SUBJECT: PLANS AND PROPOSAL ADDENDUMS

PROJECT: BR 2B23(020)

CONTROL: 0314-05-046

**IH-20  
EB ML IH 20 OVER SOUTH FORK  
PALO PINTO CREEK BRIDGE  
BRIDGE LAYOUT**

**IH-20  
SOUTH FORK PALO PINTO  
BRIDGE  
TYPICAL SECTION**

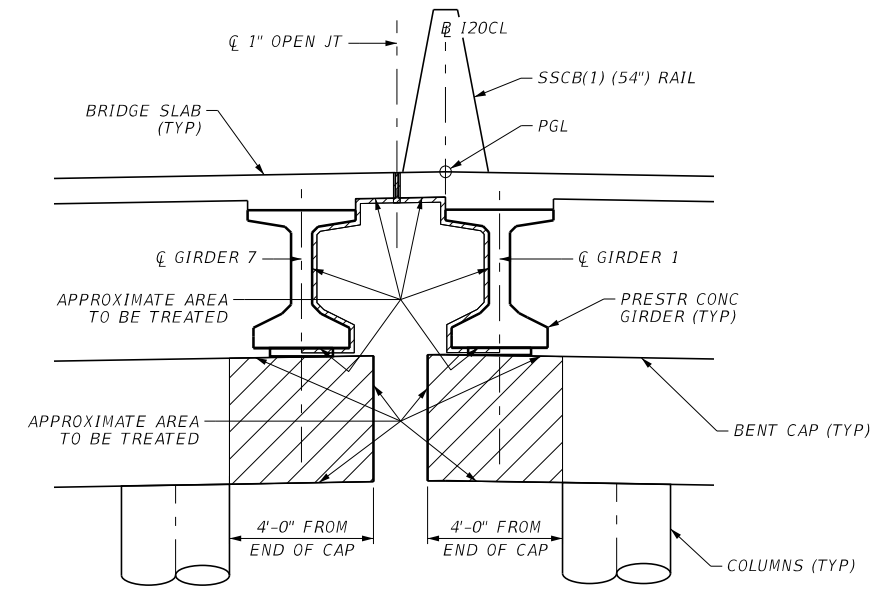
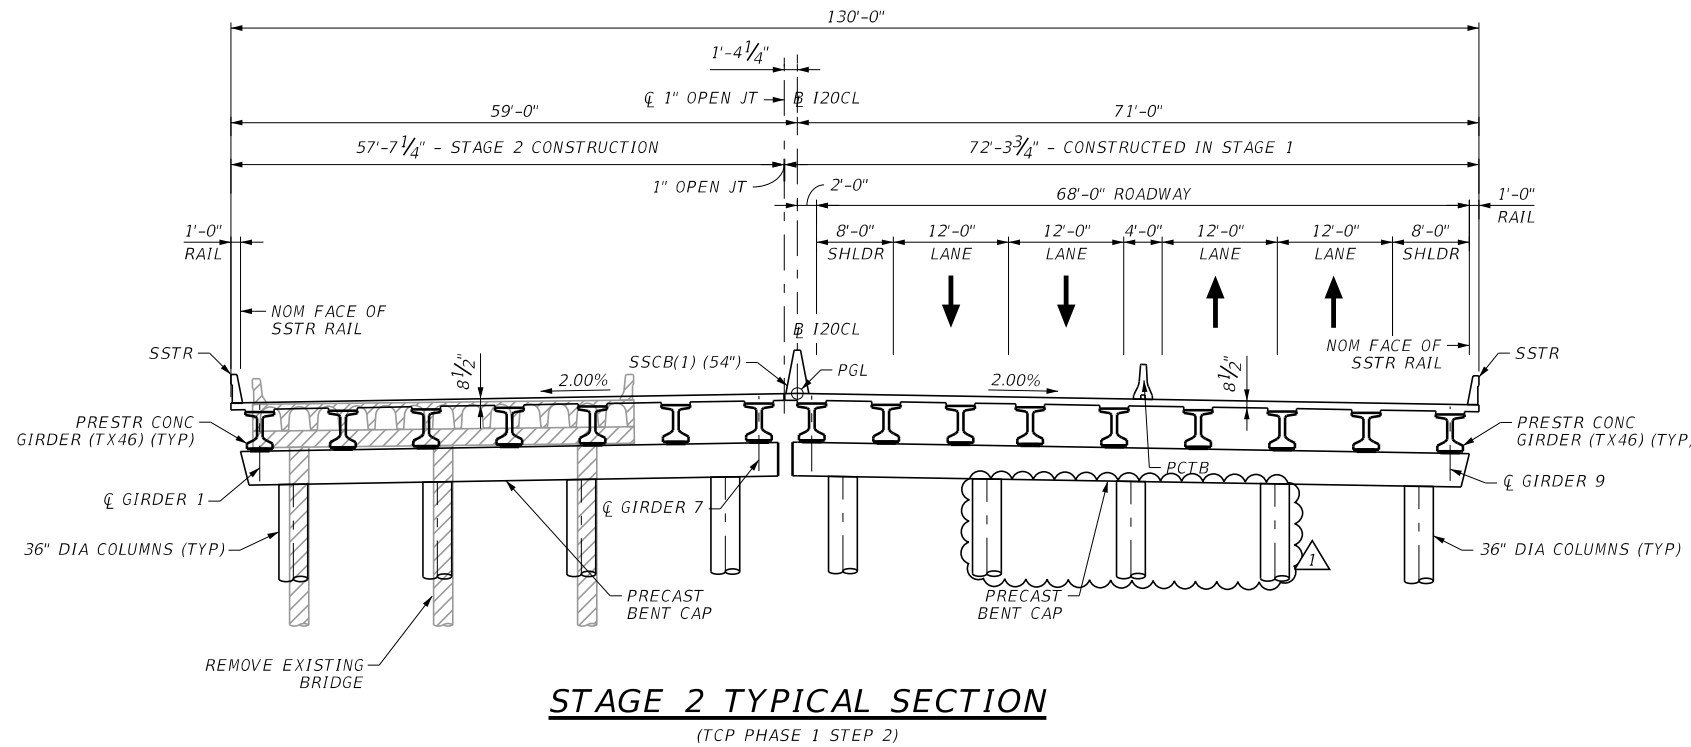
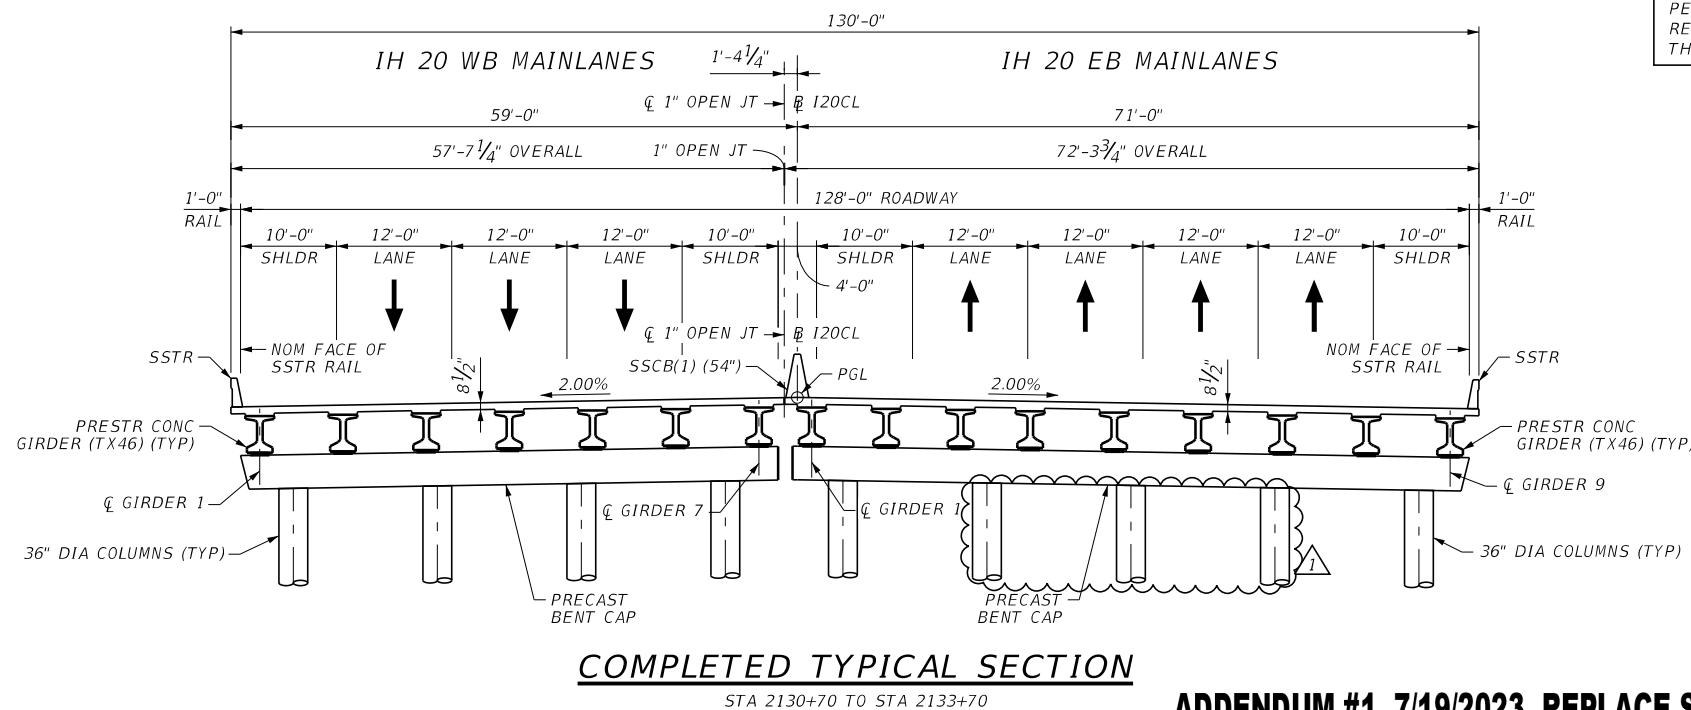
NO.	DATE	DESCRIPTION	APPROV.
1	07/18/23	ADDENDUM 01 ADDED 1 COLUMN AT INT BENTS	KH

**IH-20**  
**EB MAINLANES IH 20 OVER SOUTH FORK PALO PINTO CREEK BRIDGE FOUNDATION LAYOUT**

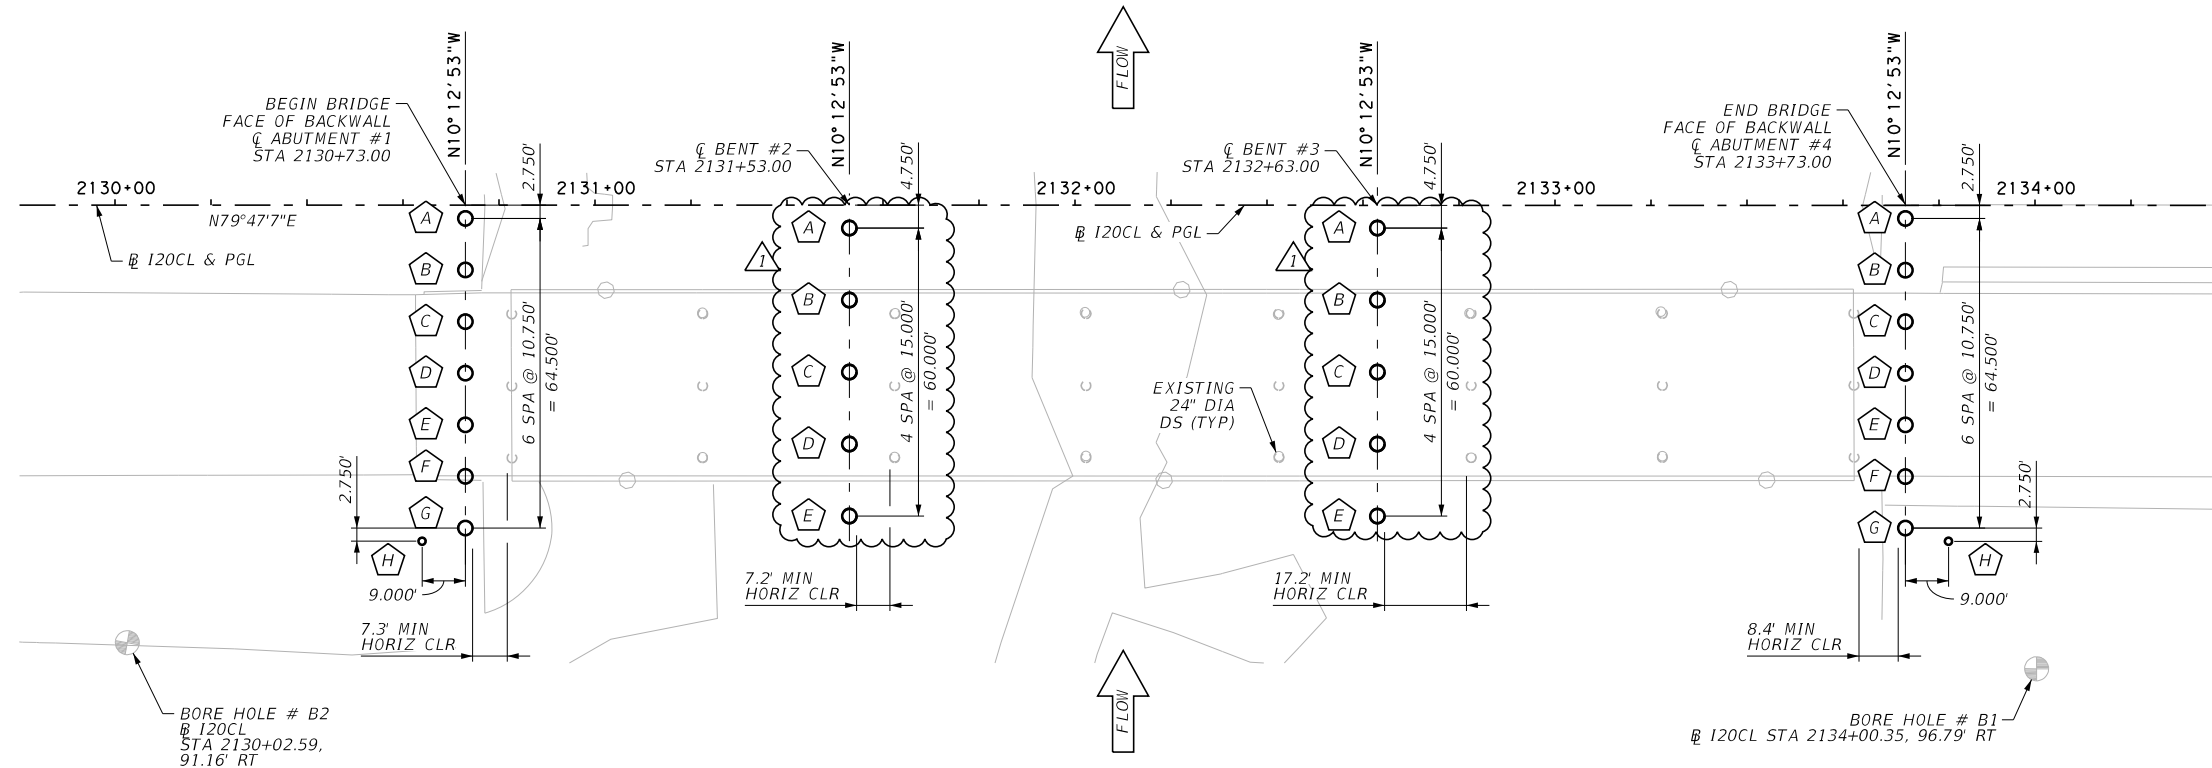
1	07/18/23	ADDENDUM 01	ADDED 1 COLUMN AT INT BENTS	KH
---	----------	-------------	-----------------------------	----

IH-20  
**EB MAINLANES IH 20 OVER  
SOUTH FORK PALO PINTO CREEK BRIDGE  
BENTS 2 & 3 DETAILS**

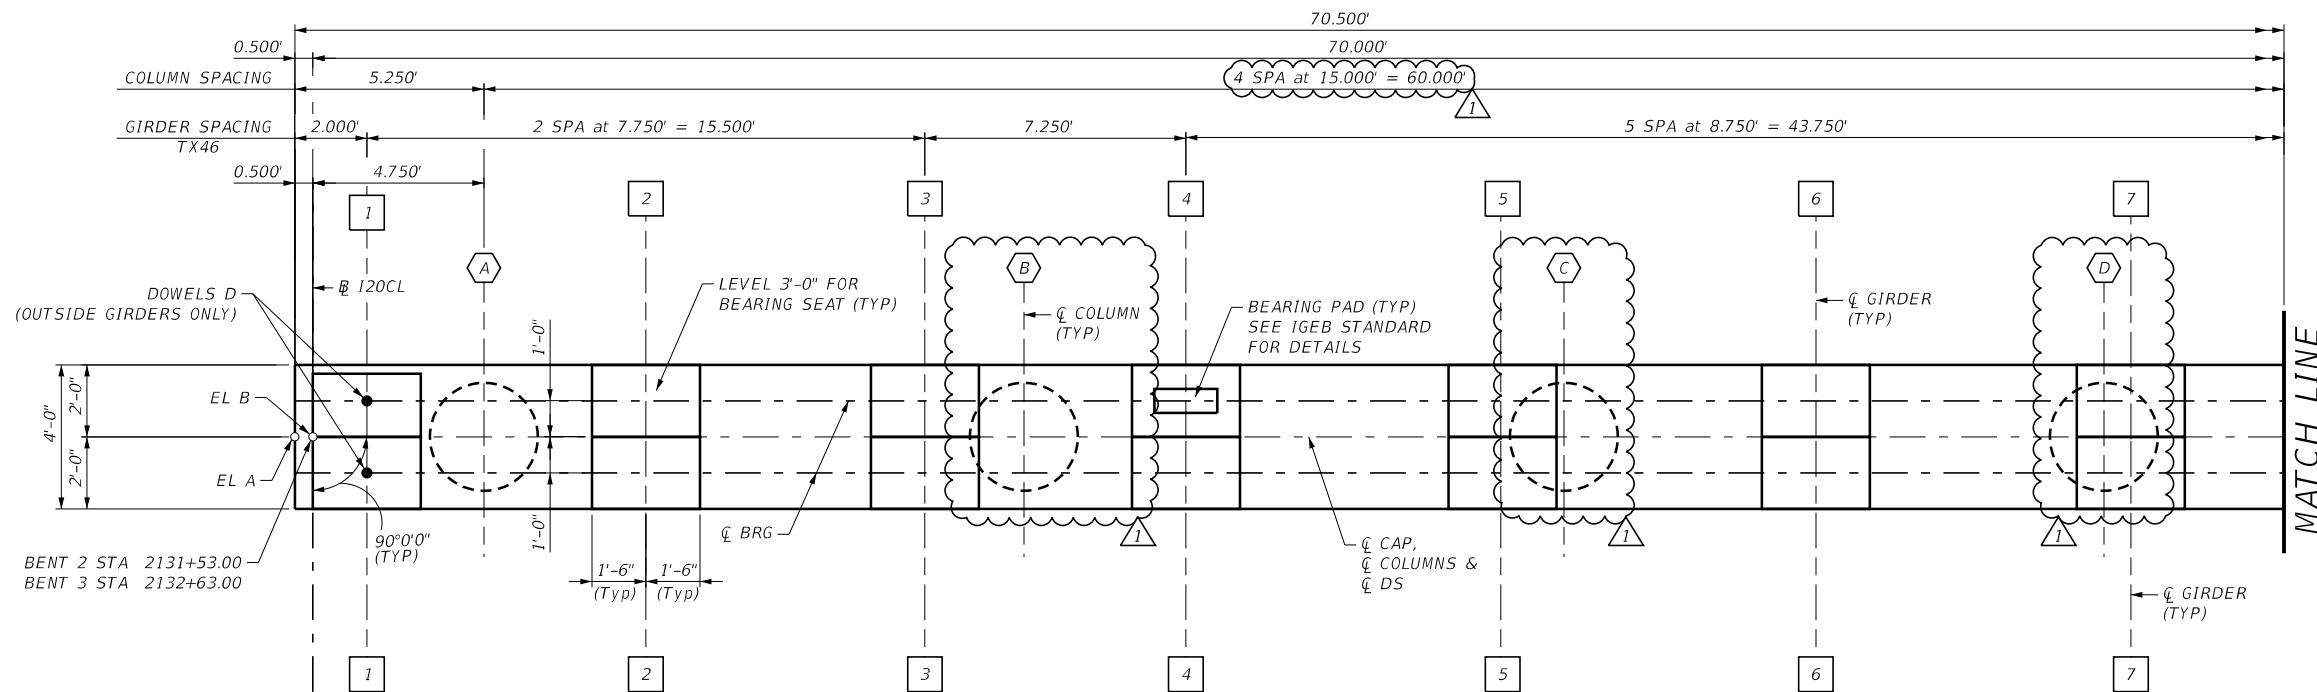
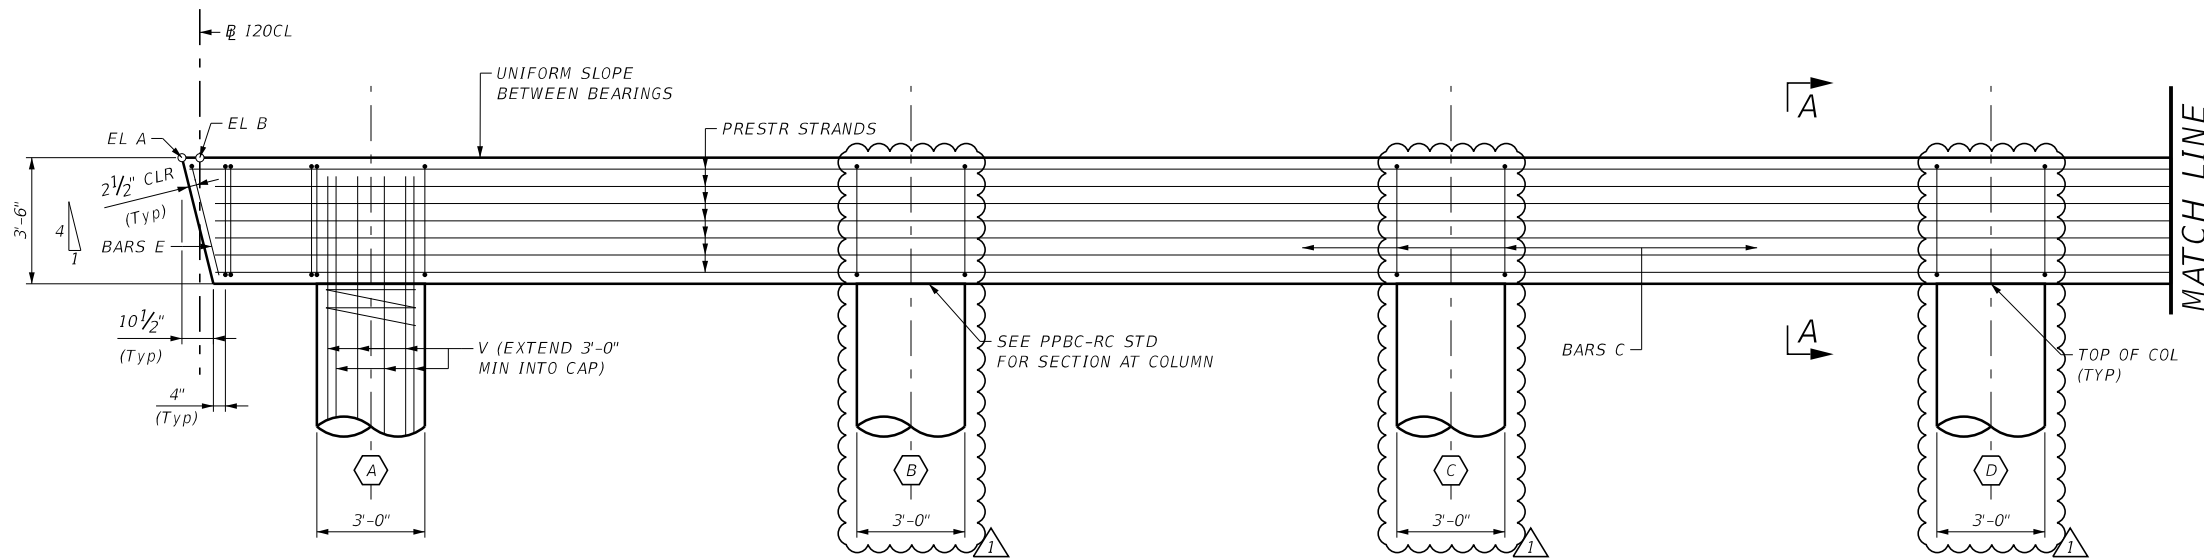
NO.	DATE	DESCRIPTION	APPROV.
1	07/18/23	ADDENDUM 01 ADDED 1 COLUMN AT INT BENTS	KH

**IH-20**  
**EB MAINLANES IH 20 OVER**  
**SOUTH FORK PALO PINTO CREEK BRIDGE**  
**BENTS 2 & 3 DETAILS**

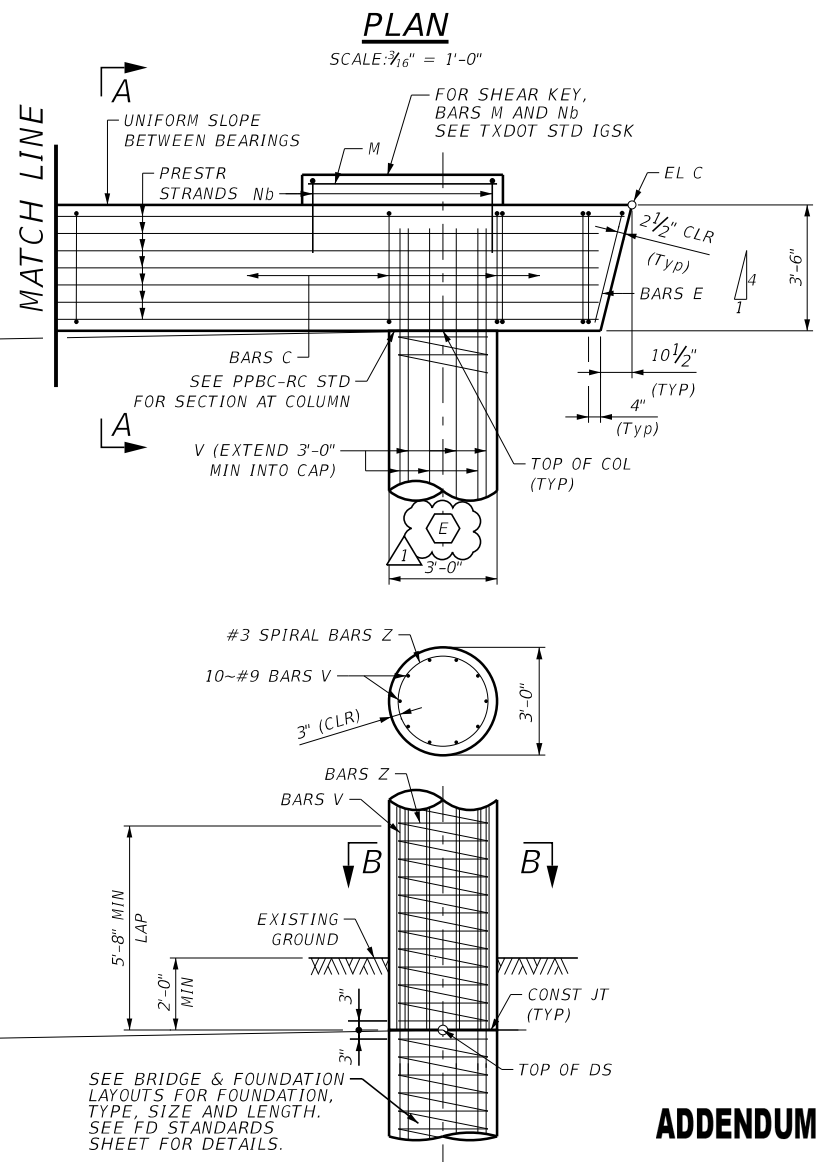
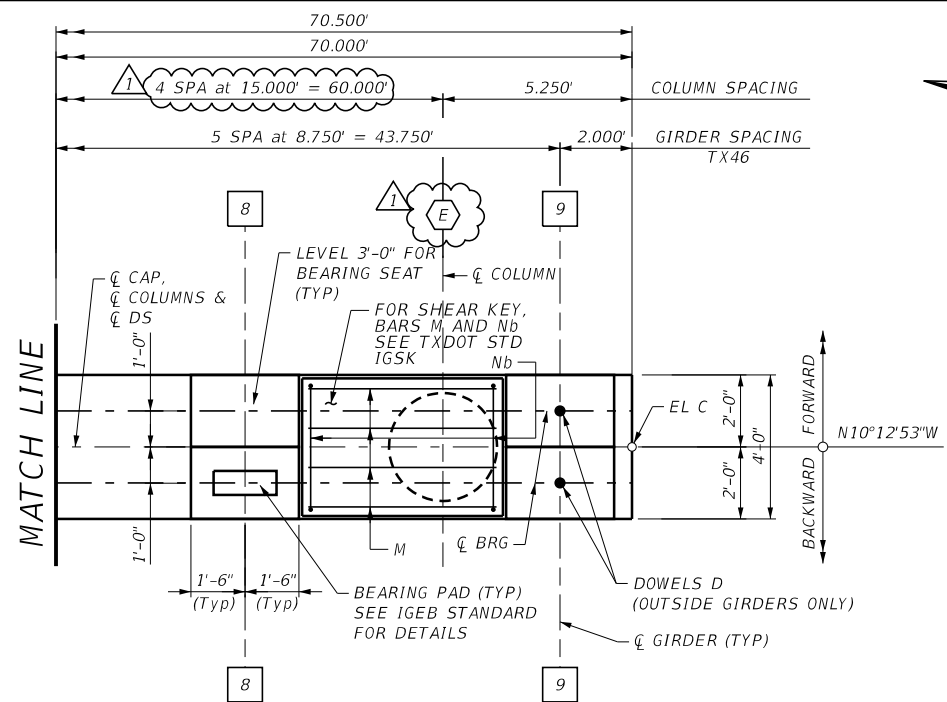
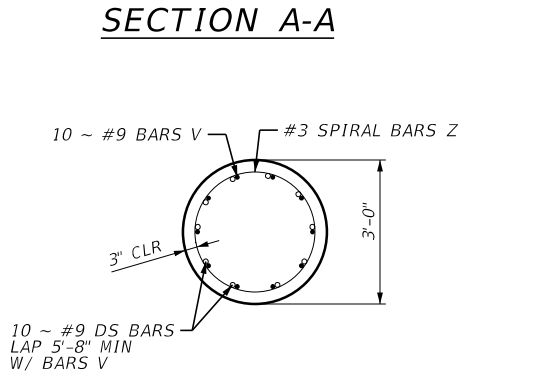
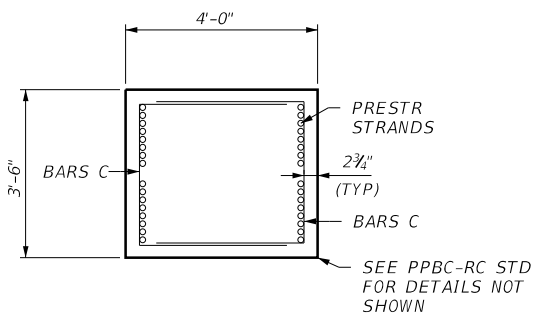
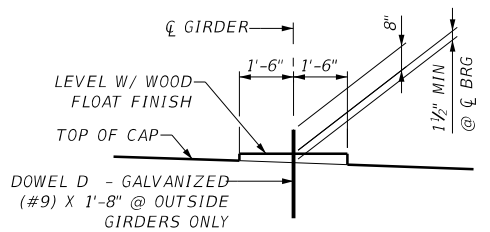
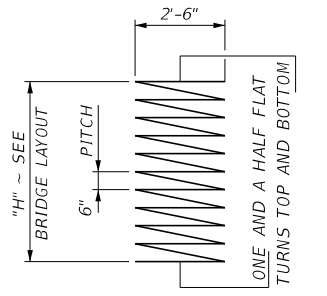
NO.	DATE	DESCRIPTION	APPROV.
1	07/18/23	ADDENDUM 01 ADDED 1 COLUMN AT INT BENTS	KH
